Re: Comments on USNRC Regulatory
Guides

1. Proposed Revision 3 to Regulatory Guide 1.35, "Inservice Inspections of Ungrouted Tendons in Prestressed Concrete Containments", dated April, 1979.
2. Proposed Regulatory Guide 1.35.1 "Determining Prestressing Forces for Inspection of Prestressed Concrete Containments", dated April, 1979.

CC-9000 DRAFT OF ASME CODE SECTION III, DIVISION 2

COMMENTS ON PROPOSED NRC REGULATORY GUIDE 1.35.1 (DATED 4/79)

TOTAL LOAD INDUCED STRAIN VS TIME

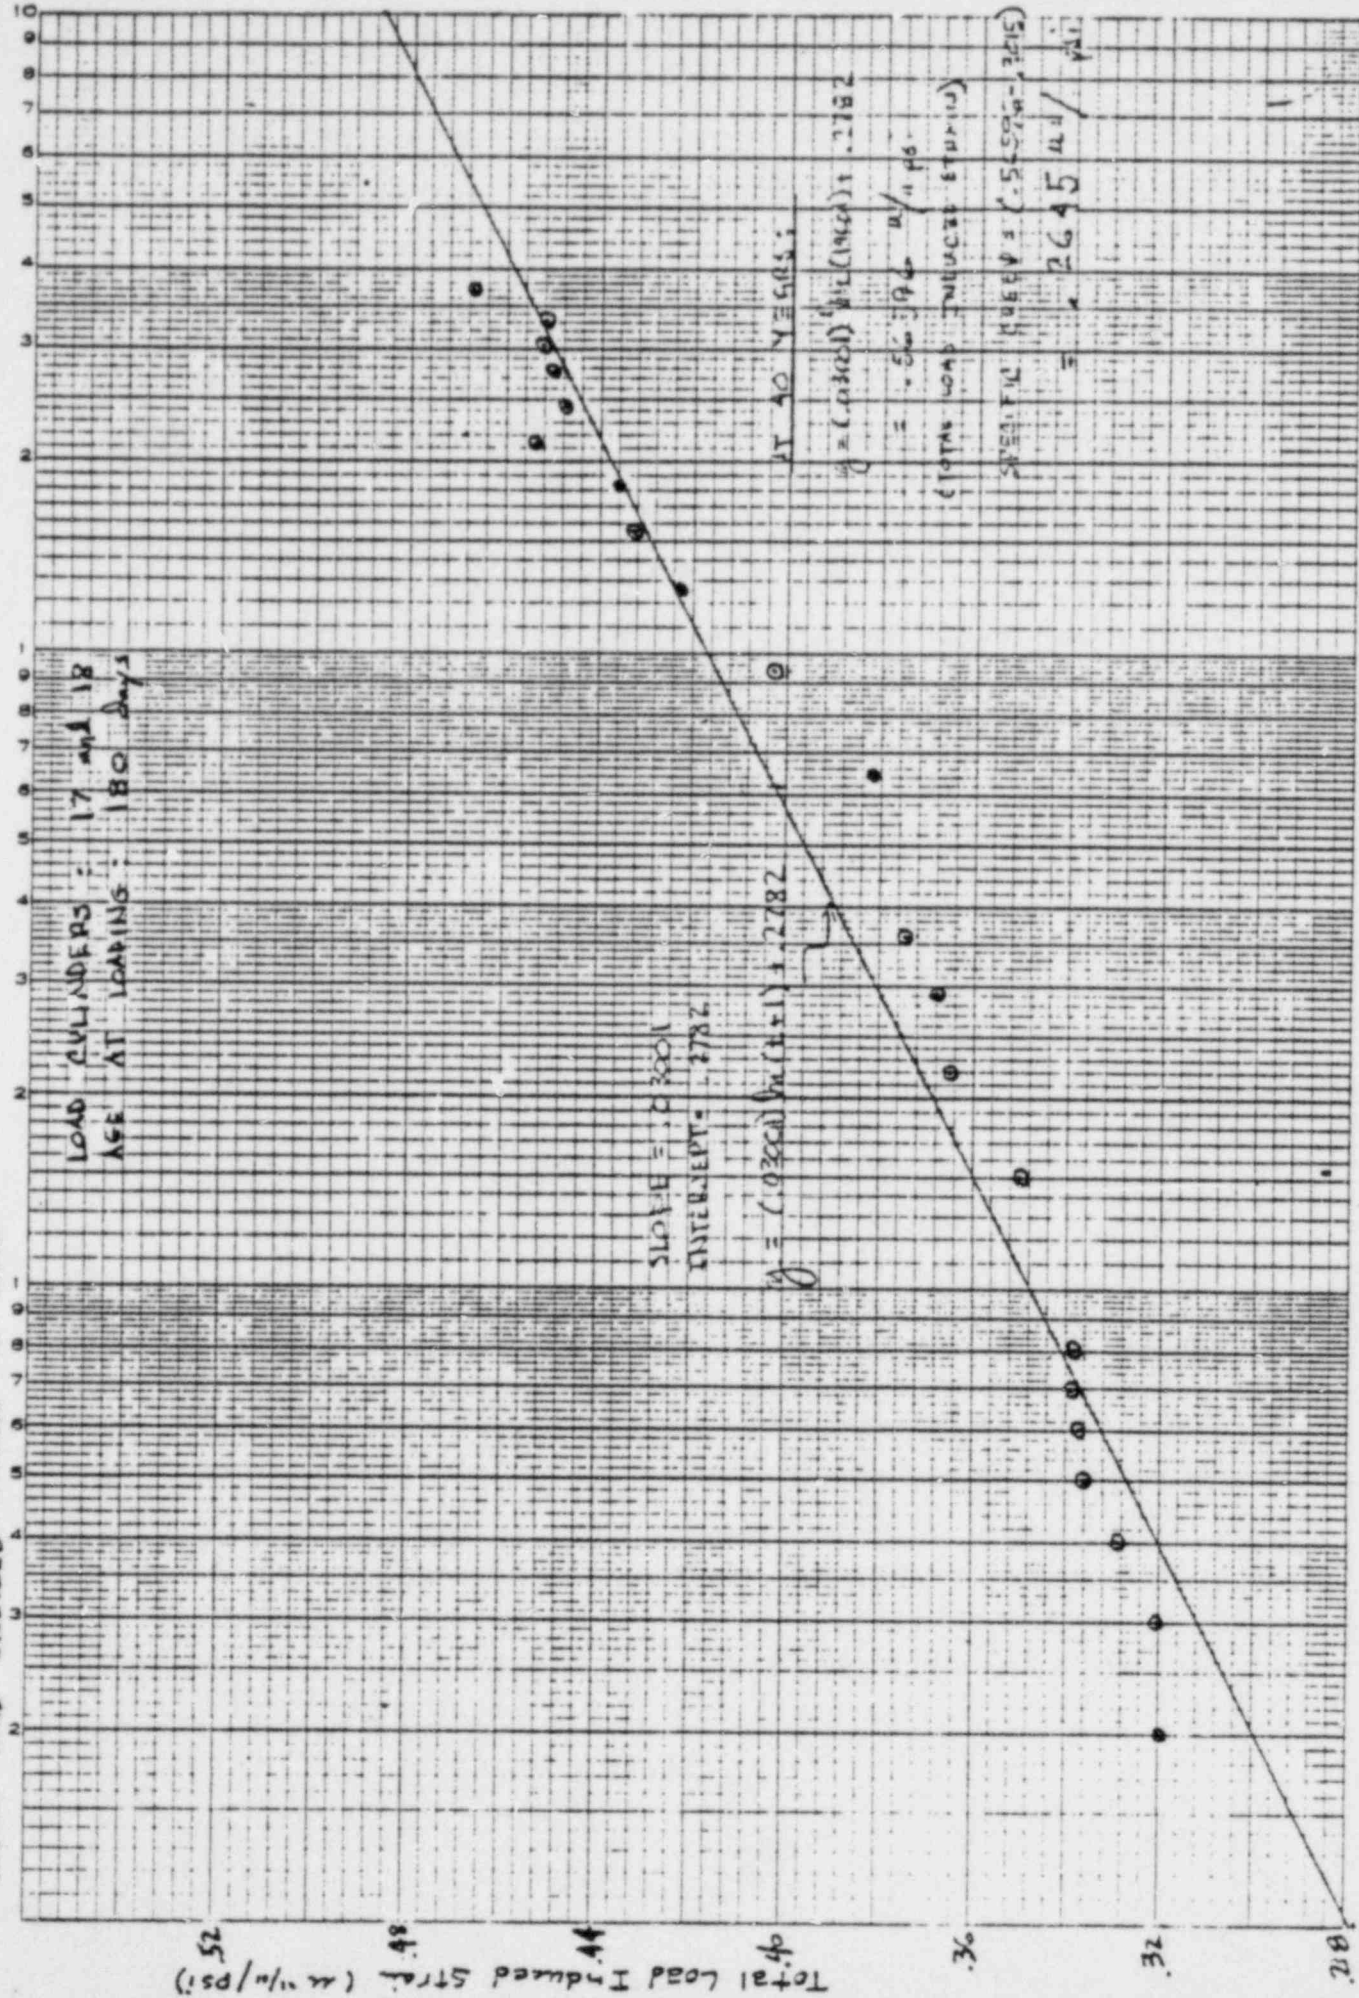
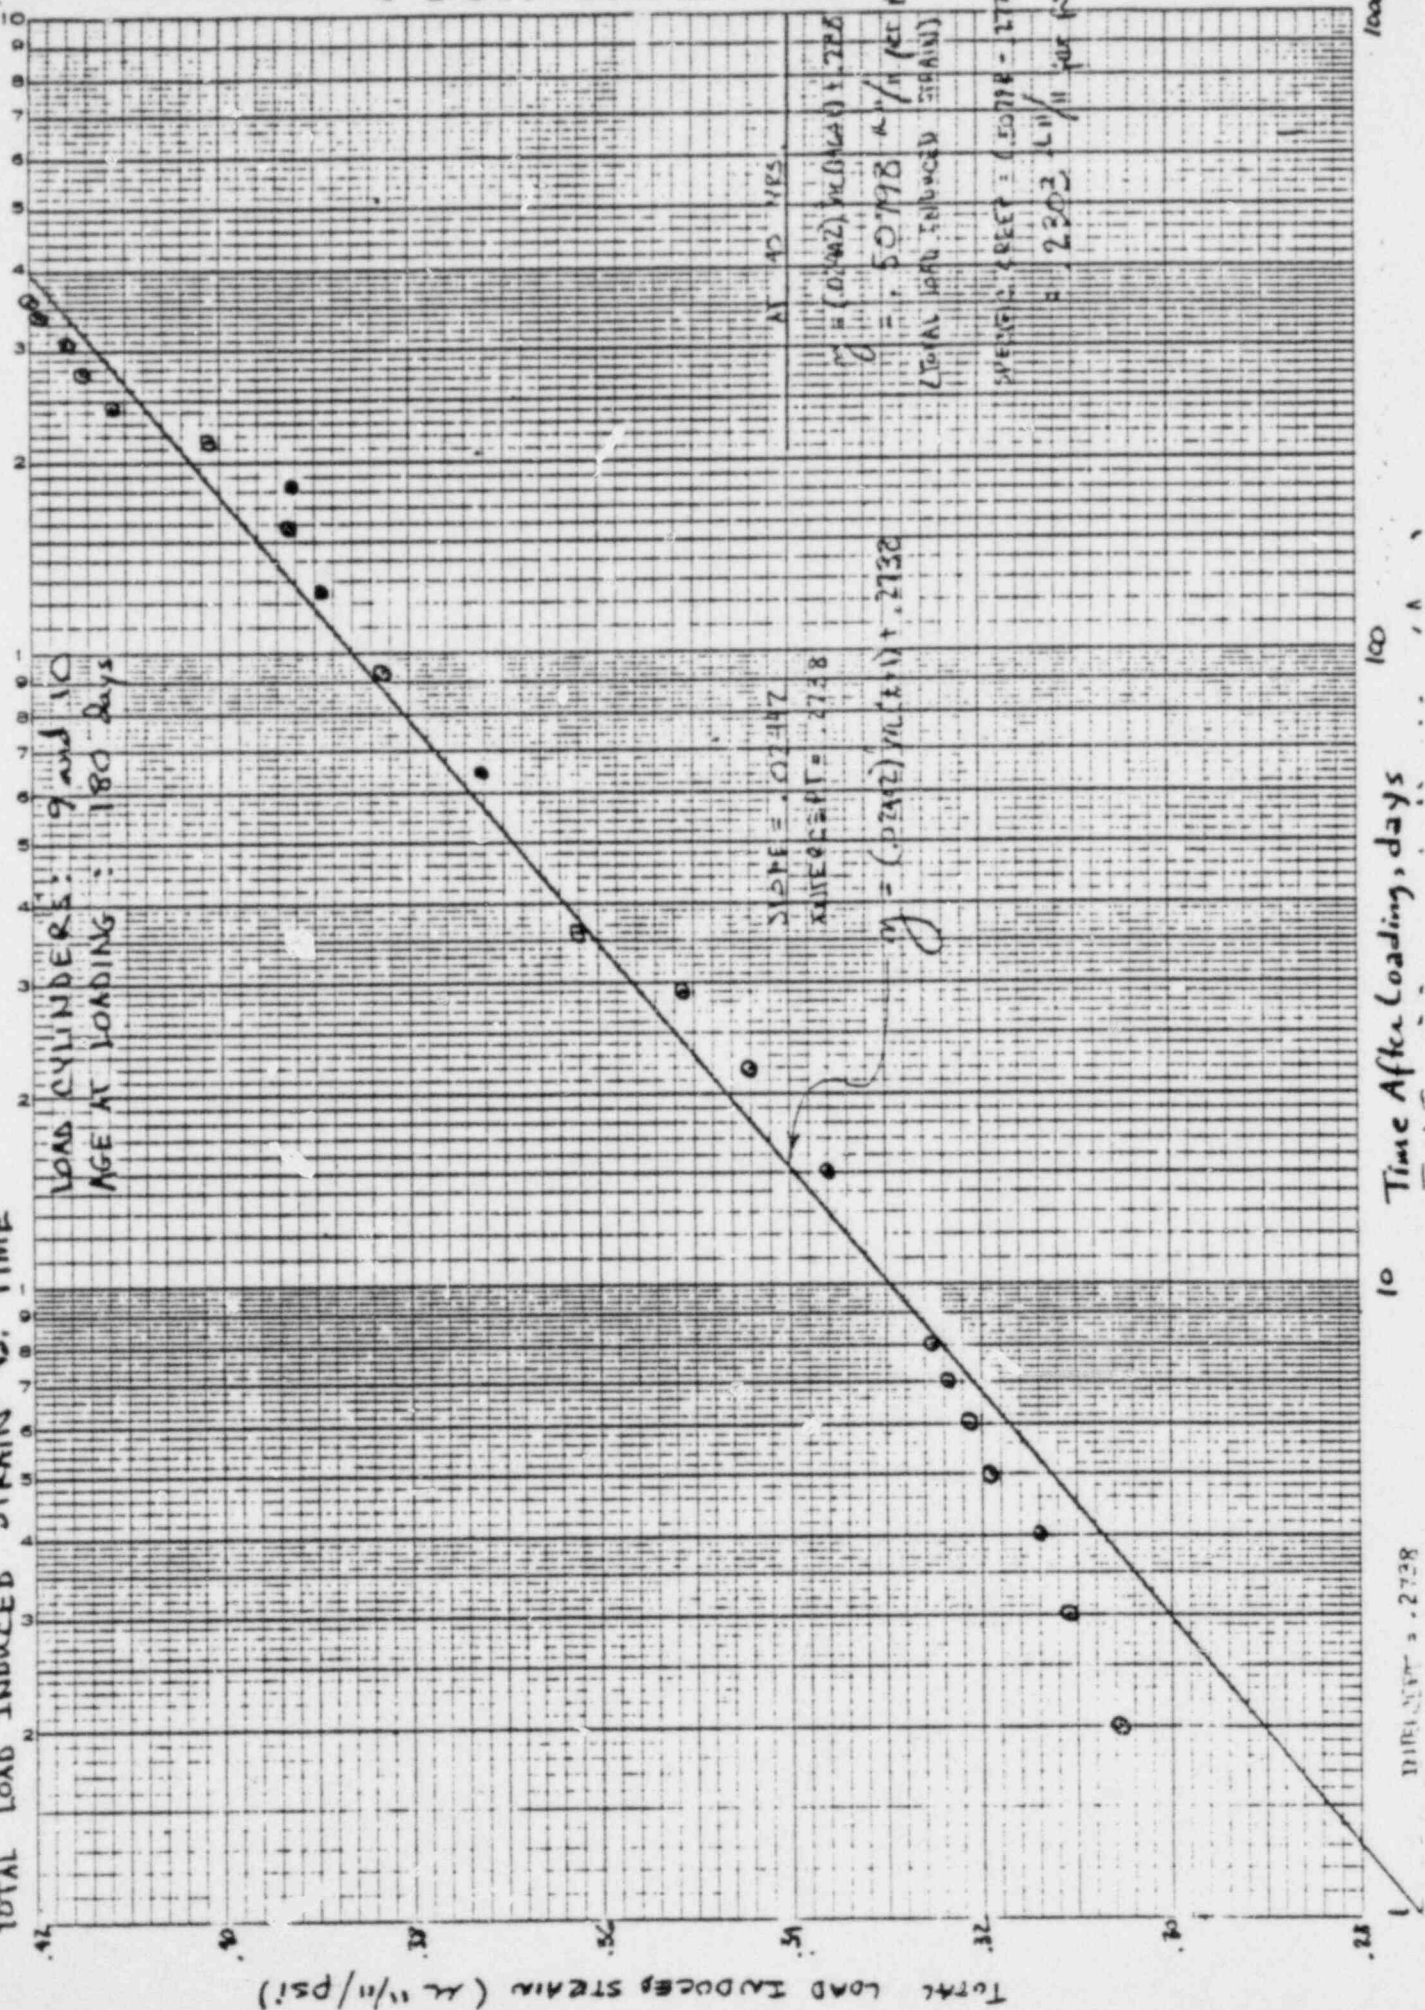
2.2.2 Effect of Concrete Creep - The recommended formula for specific creep in Appendix A is acceptable; however, the recommended number of minimum observations is far too small and should be revised to include the number specified by ASTM C 512. The values for A and B appearing in the formula should be obtained from values of specific creep (at t_1 , t_2 , and t_3) picked off a linear regression fit to the creep data. The creep data consists of values measured at the times after loading specified in ASTM C 512. This revision is necessary because the creep data oscillates about a line of best fit and use of three data values at t_1 , t_2 , and t_3 , rather than creep values off this line, produces erroneous values of A and B. The attached plot of some creep data illustrates this (concrete cylinders loaded at 180 days). From this data, the 40 yr. specific creep (micro inches per inch per psi) were calculated:

Cylinders	Linear Regression	Existing* App. A	Proposed** App. A
17/18	0.27	0.48	0.29
9/10	0.23	0.18	0.23

169,25mm wire tendon

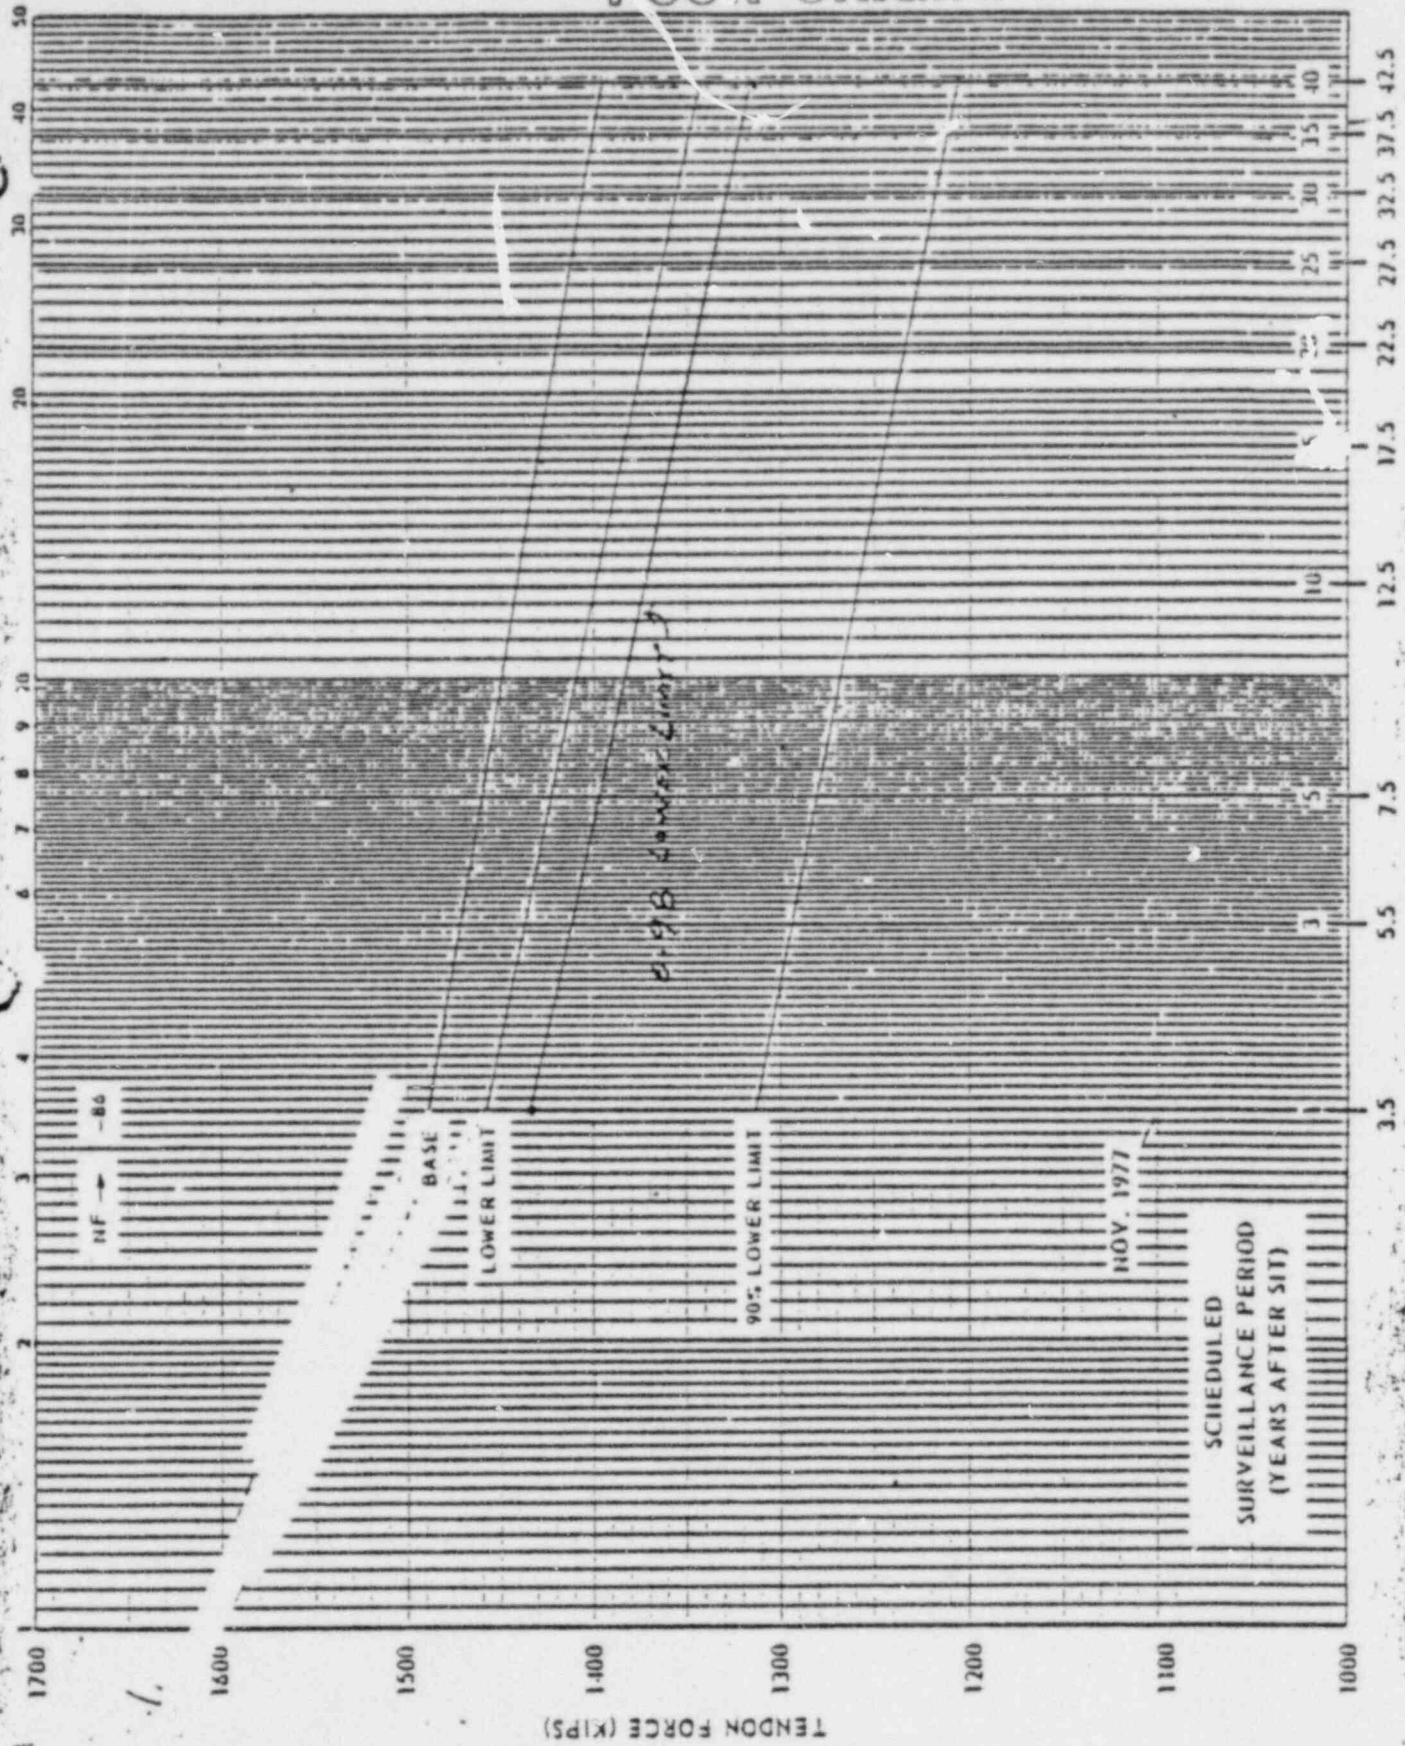
Incorporation of Lift Off Force Measurement Error into Lower Limit - The two attached Predicted Force-versus-Time curves illustrate the significance of a 2% measurement error. One figure is for a 169 wire tendon; the other applies to a 90 wire tendon.

The Lower Limit line was established from upper bound losses as per the Reg Guide—
If a 2% measurement error is applied to the Lower Limit curve, the 0.98 Lower Limit line results. From a discussion of the measurement accuracy of lift off forces with post tensioning vendors, a 2% error is realistic.

From the figures, it is seen that the force corresponding to a 2% measurement error is about the same as the upper bound loss tolerance. Thus, the Lower Limit should include the 2% measurement error. Its effect on the 90% Lower Limit line would not be as significant; consequently, the 2% error does not have to be applied to the 90% Lower Limit.

28 kip error is roughly 10% of the 40 yr. long term loss that is predicted for a tendon. Thus, the error in measuring the lift off force is not insignificant. In light of this, the Lower Limit established in the proposed Reg Guide should be re-defined to include a 0.98 factor, which represents the 2% error.
